This is to certify that PEARL PROPERTIES	S LLC /Jae Reynolds	- 2
has permission to <u>Mixed Use amendmen</u>	at to permit# 081124 4 story addition to 3 stor	addition w/ mezzanine & Eleca M
AT _61 INDIA ST	CBL	020 E021001
		ing this permit shall comply with al
	Control of the Contro	s of the City of Portland regulating
this department.	nd use of buildings and structu	res, and of the application on file in
Apply to Public Works for street line and grade if nature of work requires such information.	Notification of inspection must be given and written permission grocured before this building or part thereof is lathed or otherwise closed-in. 24 HOUR NOTICE IS REQUIRED.	A certificate of occupancy must be procured by owner before this build-
OTHER REQUIRED APPROVALS		1
Fire Dept.		/ 10 /
Health Dept.		m. 15 1 - 7/ /
Appeal Board		Mukance / bill
Other	\	Director - Building & Inspection Services

Amendment to approved Site Plan

India St; 61, Change Of Story To 3 With Mezzanine, Joe Reynolds,

SOUTH WEST ELEVATION

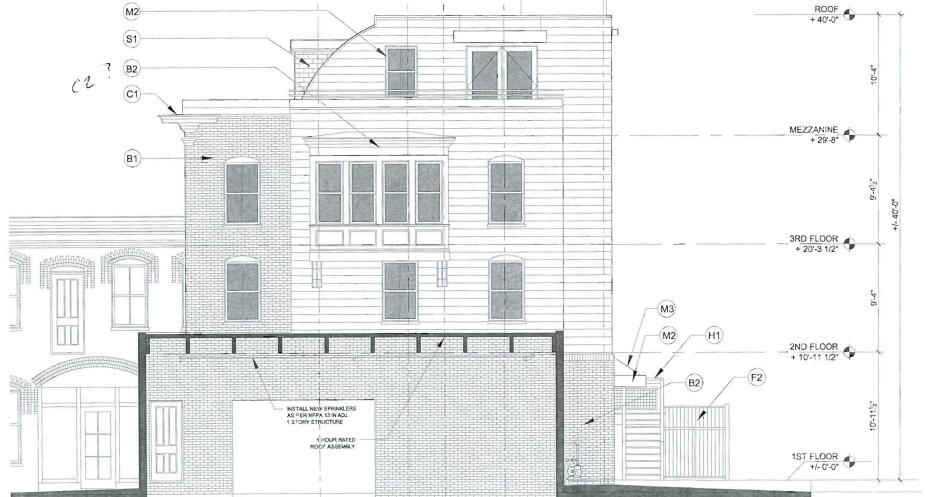
- The exterior balcony guard detail as shown in drawing A2.1 shall meet code requirements as described in Section 1013 of the 2009 UBC (with a minimum height of 42" A.F.F.).

- vii. That Plans A2.1. A2.2, A2.3 and A2.4 shall be revised to show the final exterior roof and cladding materials and railing specifications, to be submitted for review and approval prior to installation; and

G1.3

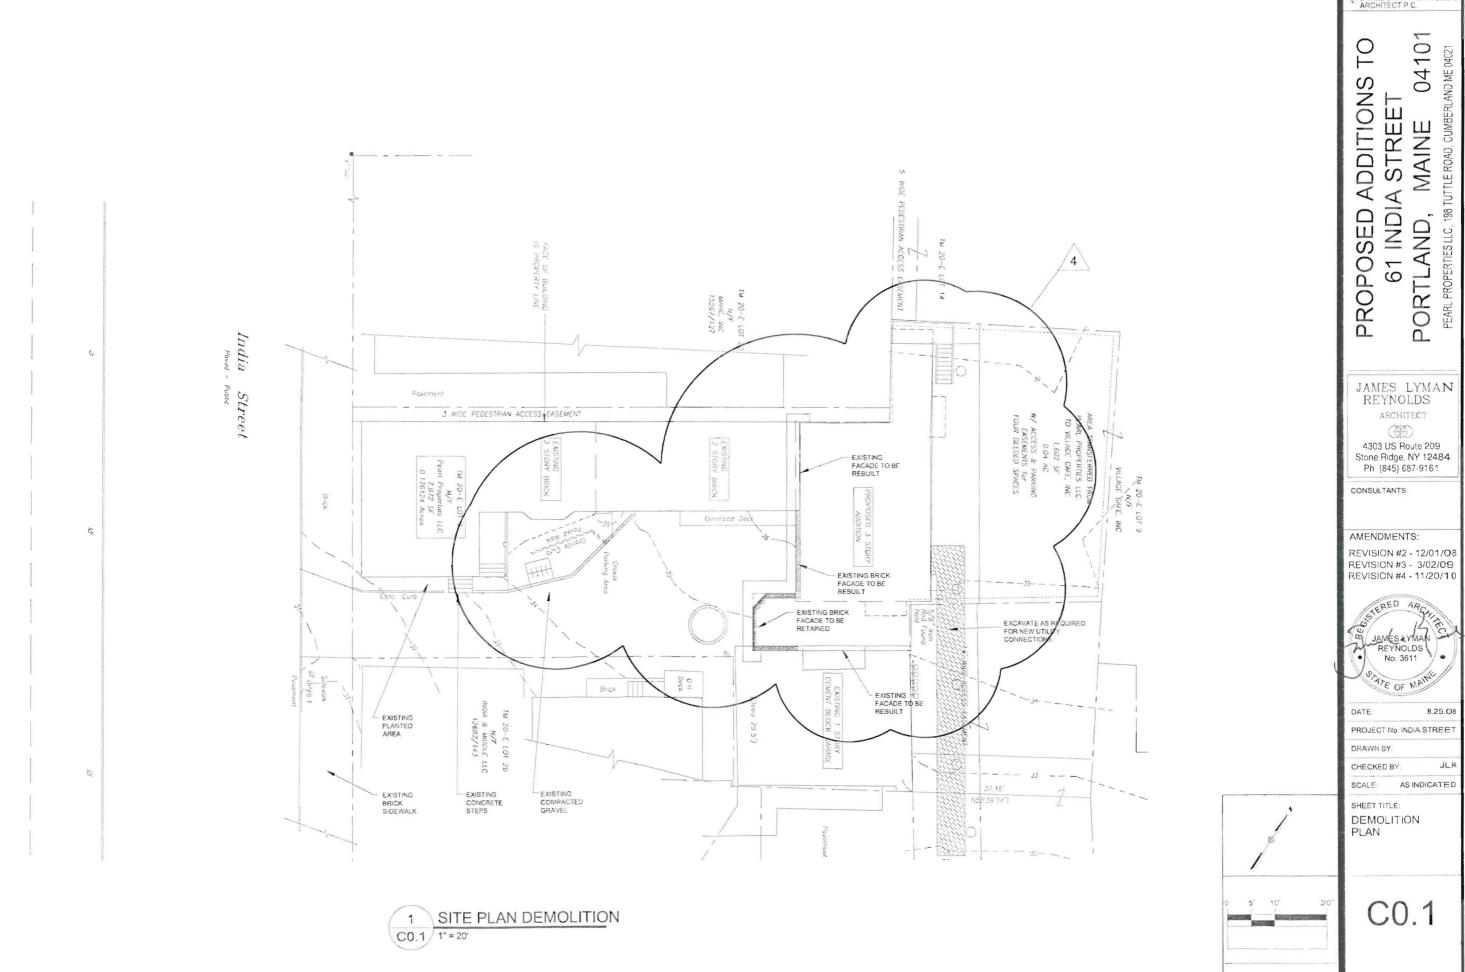
- The reference Table citation for Maximum Area of Exterior Wall Openings Base on Fire Separation Distance located on sheet G1.2 should refer to table 705.8 (and as per 2009 UBC).
